Tuesday, 7/17/2007 2:00:47 PM Kim Johnston **Process Sheet** : SUPPORT ARM : CU-DAR001 Dart Helicopters Services **Drawing Name** Customer : 33593 Job Number : 11669 **Estimate Number** : D2846 Part Number P.O. Number D2846 REV A **Drawing Number** : 7/17/2007 S.O. No. : This Issue : N/A : NC Project Number Prsht Rev. : A : MACHINED PARTS **Drawing Revision** : 11 Type First Issue Material Previous Run : 8/15/2007 Qtv: Due Date Written By Checked & Approved By Added Inspection Level 8 and Level 5 S : Est. Comment Μ **Additional Product** Job Number: Description: Machine Or Operation: Seq. #: D6102005 Billet 1X15.25X48' 1.0 Comment: Qty.: 12.0000 Each(s) 1.0000 Each(s)/Unit Total: Billet 1X15.25X48" Pick Billet: D6102-005 (15.25" x 48.00" x1.00") Note: 1 Billet makes 3 parts 。Batch No: <u>B分36</u>60 HAAS CNC VERTICAL MACHINING #1 HAAS1 Comment: HAAS CNC VERTICAL MACHINING #1 Machine per Folio FA194 . 1 Deburr INSPECT PARTS AS THEY COME OFF MACHINE 3.0 QC2 Comment: INSPECT PARTS AS THEY COME OFF MACHINE SECOND CHECK 4.0 QC8 Comment: SECOND SMALL & MEDIUM FAB RESOURCE 1 5.0 SMALL FAB 1

Subject: RE: NCR D2846

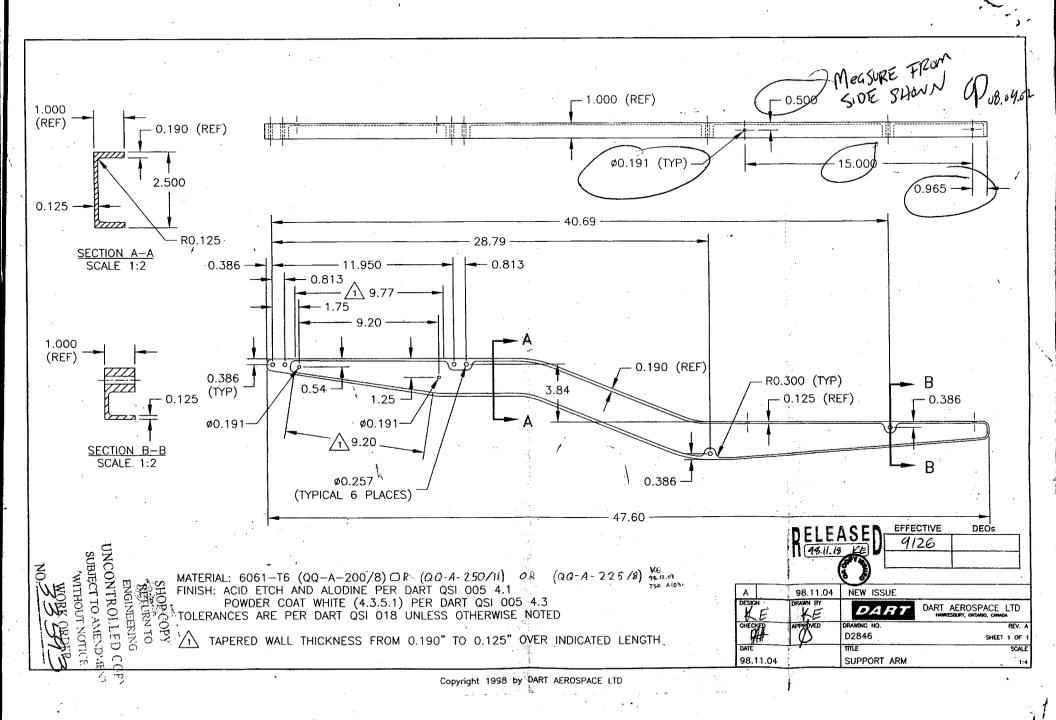
WORK ORDER NON-CONFORMANCE (NCR) NCR:33593 **Corrective Action** Section B **Description of NC** Verification Approval **Approval** DATE **STEP** Initial **Action Description** Sian & Section A Chief Ena Seation C QC Inspector 68.04.16 5.0 it was bolted on fer drilling R.C. Shim on the jig was not proporty placed, and the bolt tightened into the material. Very small. Chief Eng Chief Eng Date Fill Area with well paraslow grand flush debir. Qty I part only
